LANDSIDE ACCESS MODERNIZATION PROGRAM

ITF-W_A Interim Ground Access (IGA) **Project # DA-5305A**

Package Transmitted For	Delivered Via	Tracking Number
CO-0008-PDG FULLY EXECUTED ITF-W A Interim Ground Access (IGA) Change Order #08 for CPCN No# 1007A, 1004A, 1003A, and 1011A 2019-06-21		CO-0008-PDG FULLY EXCUTED

CHANGE ORDER NO. 0008

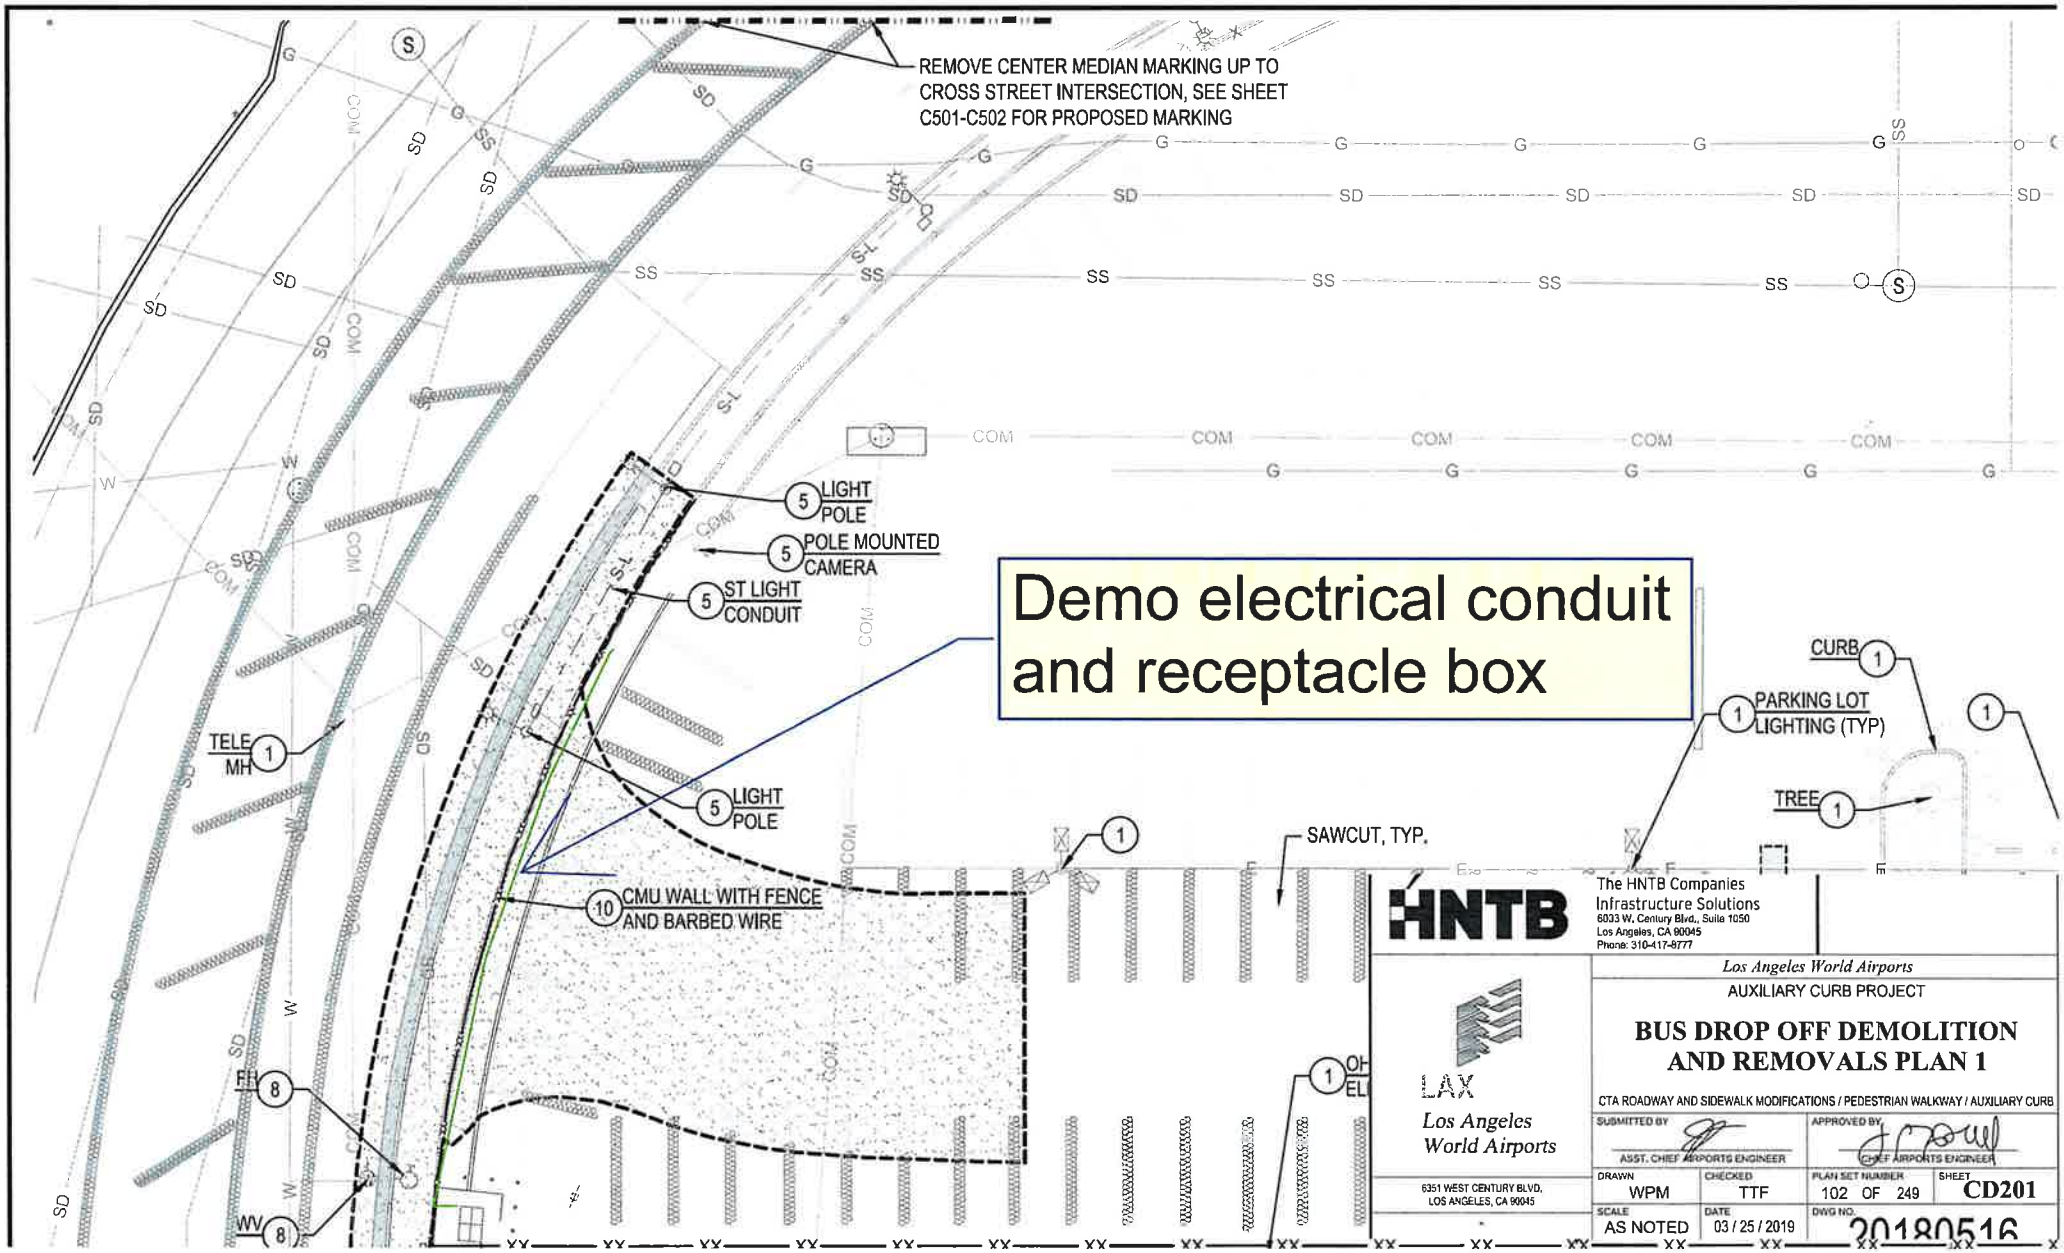
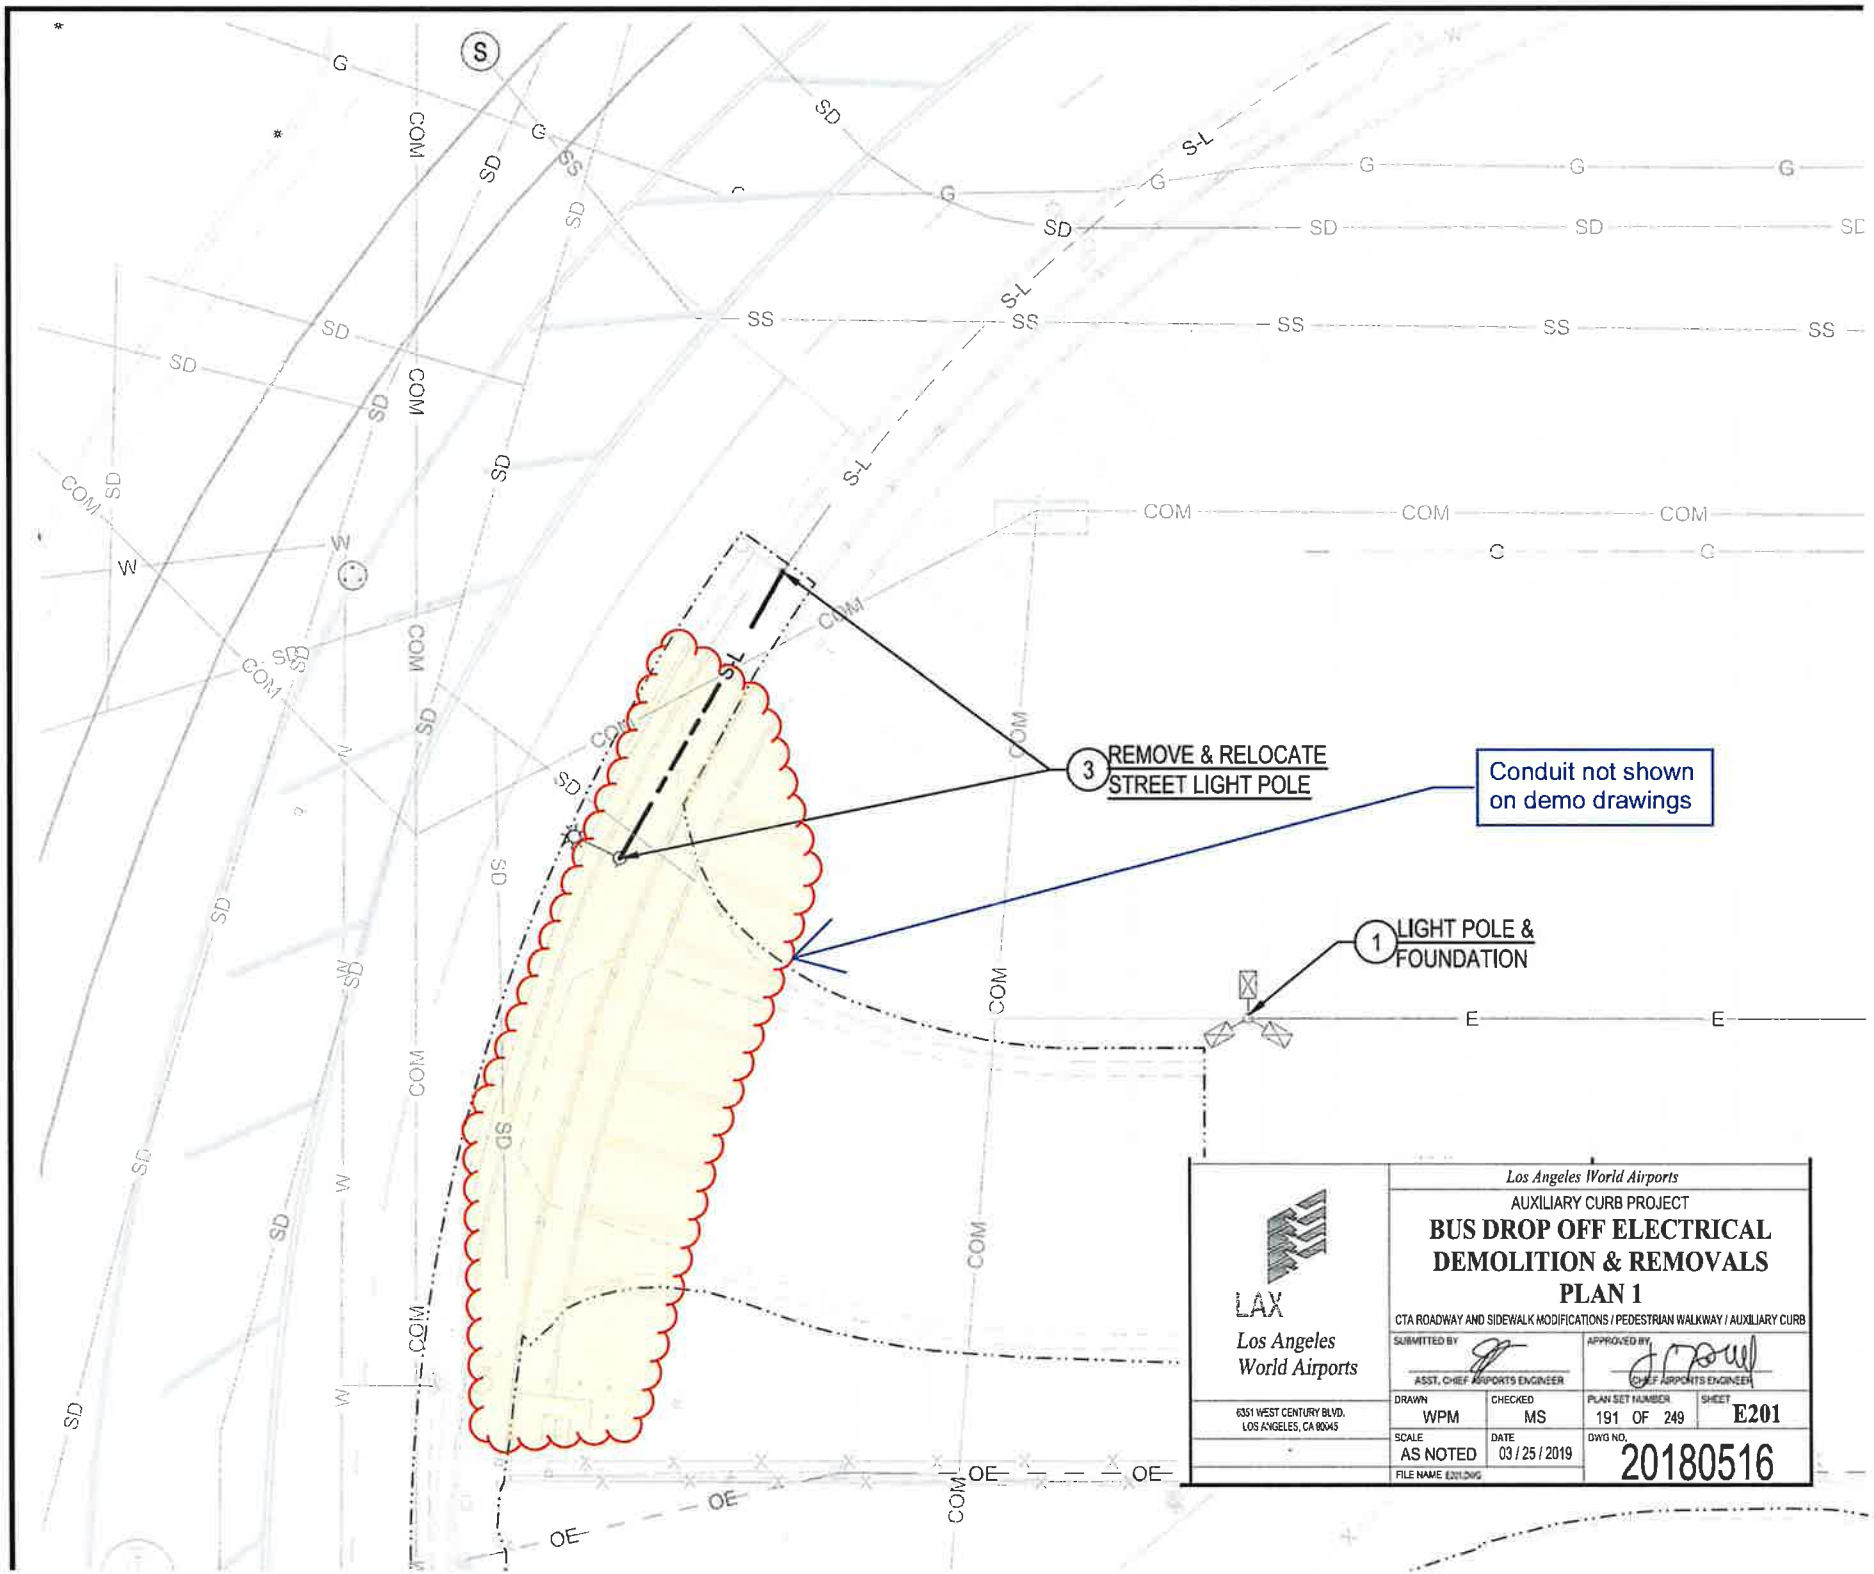
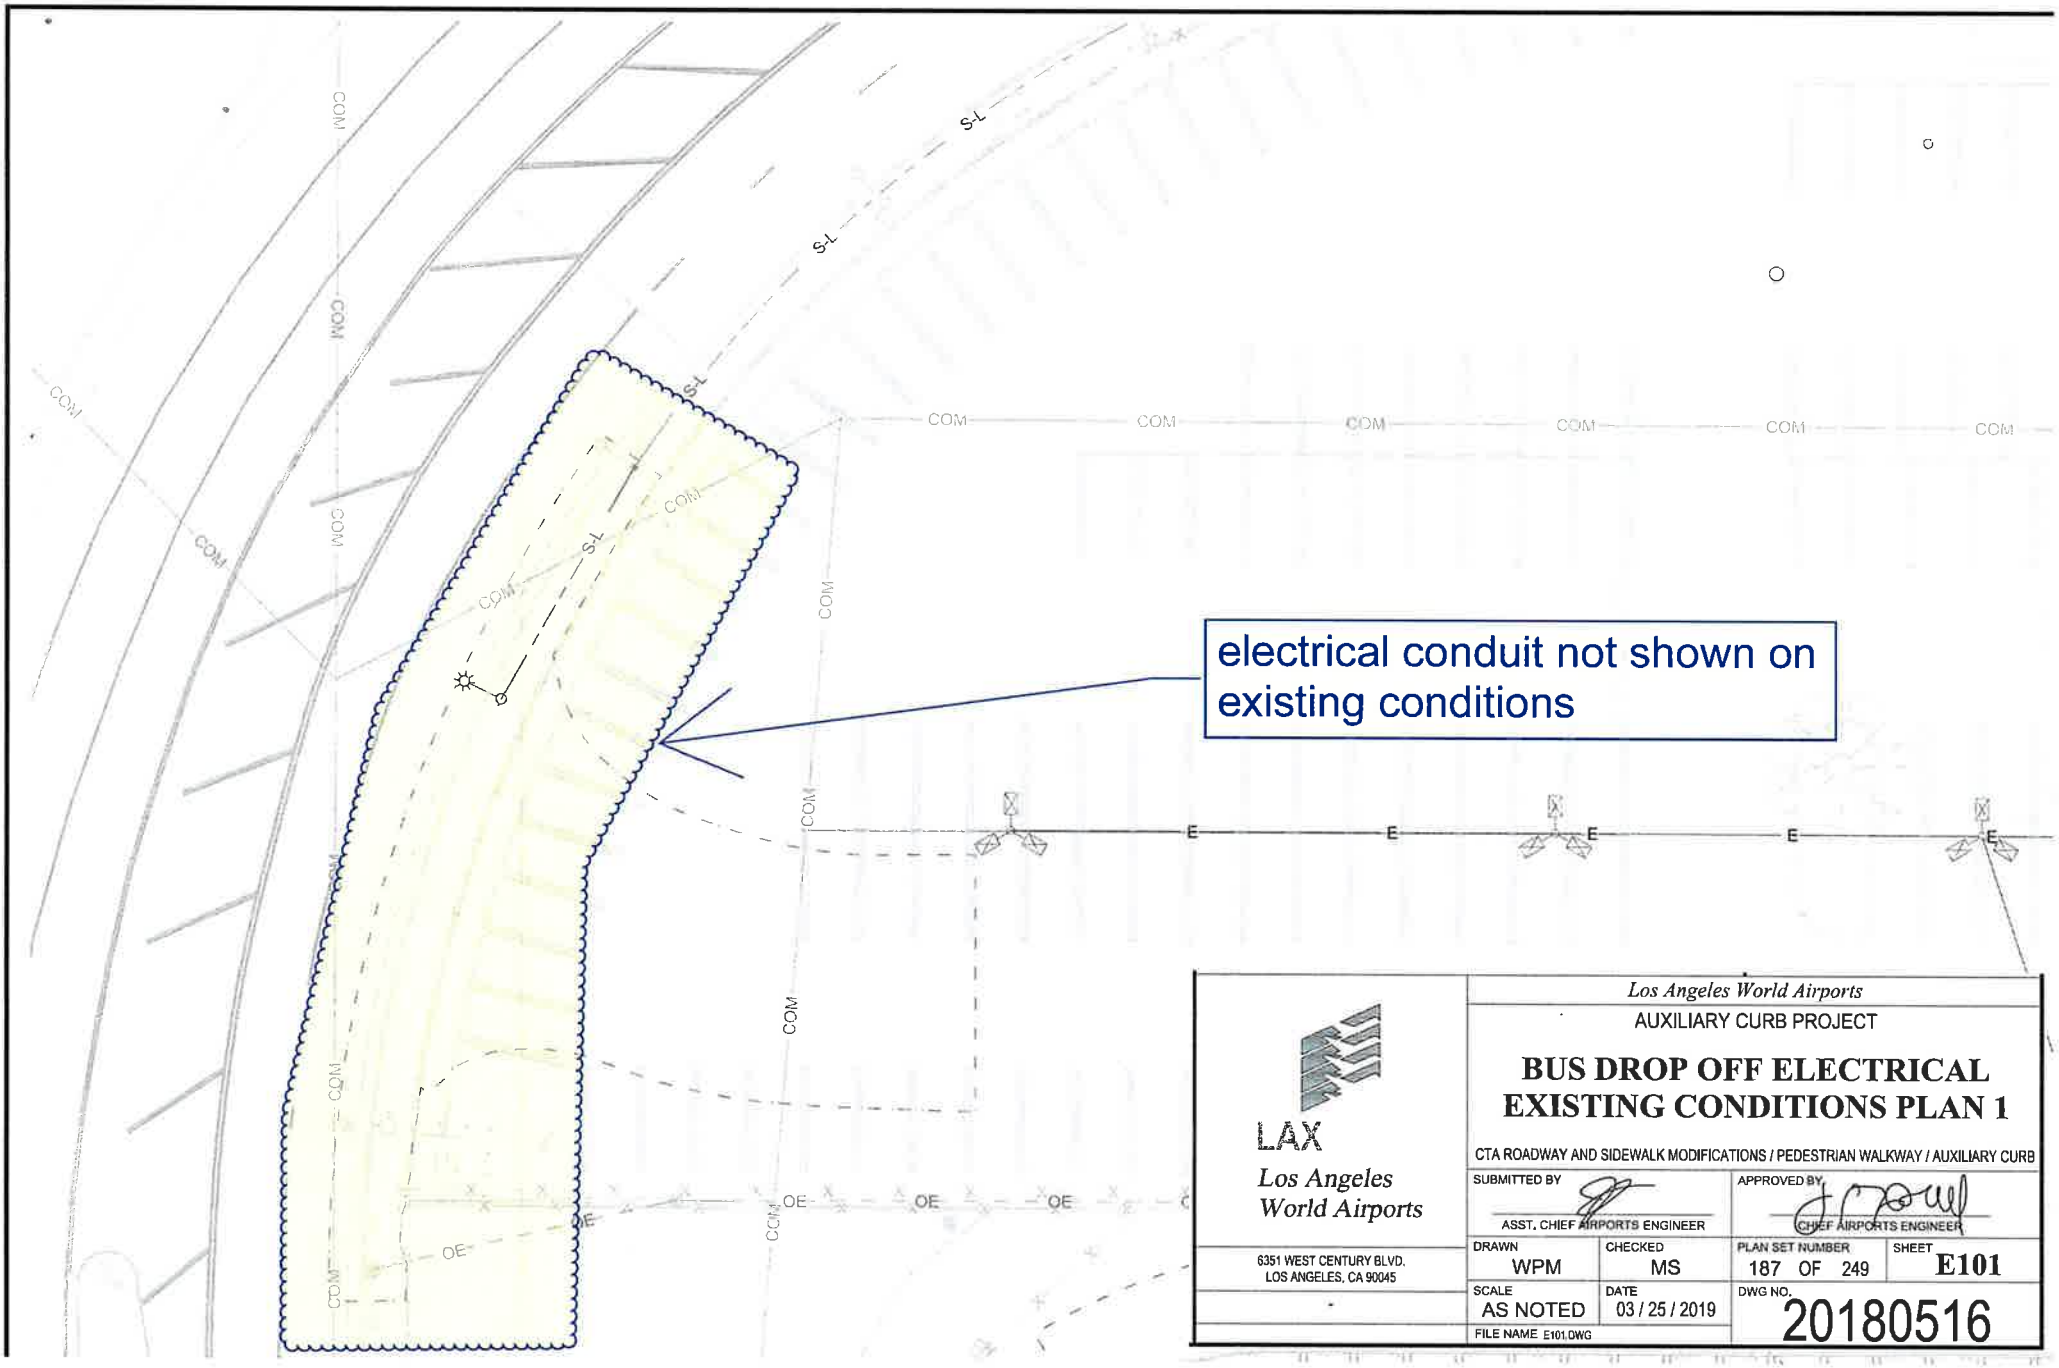
[4/9/2019 Swinerton Builders - Jones, Derrick]
Please confirm the following:
On Sheet CD201 there is an existing conduit which feeds an outlet, and is mounted on the CMU wall which is to be demolished for the new driveway approach. Demo Sheet CD201 and Elec. Demo Sheet E201 does not call for this conduit to be demolished. See attached marked up drawings. Please advise if the existing electrical conduit at electrical cabinet, and on the CMU-wall are to be removed/demoed.

NETFLIX
REGENCY
remove conduit and outlet box

electrical conduit not shown on existing conditions
COM
S-L
E
OE
LAX
Los Angeles World Airports
6351 WEST CENTURY BLVD.
LOS ANGELES, CA 90045
Los Angeles World Airports
AUXILIARY CURB PROJECT
BUS DROP OFF ELECTRICAL EXISTING CONDITIONS PLAN 1
CTA ROADWAY AND SIDEWALK MODIFICATIONS / PEDESTRIAN WALKWAY / AUXILIARY CURB
SUBMITTED BY
ASST. CHIEF AIRPORTS ENGINEER
APPROVED BY
CHIEF AIRPORTS ENGINEER
DRAWN WPM
CHECKED MS
PLAN SET NUMBER 187 OF 249
SHEET E101
SCALE AS NOTED
DATE 03 / 25 / 2019
DWG NO. 20180516
FILE NAME E101.DWG

Scope: Sheet CD201 calls for demo of the CMU wall but does not clarify direction for conduit mounted on the wall. Per direction from LAWA in RFI 0006 SB is directed to demo conduit. See attached backup documentation.

The contract adjustment required as a result of:
Added cost to demo existing conduit not shown on drawings E201. Conduit to be demolished per LAWA direction.
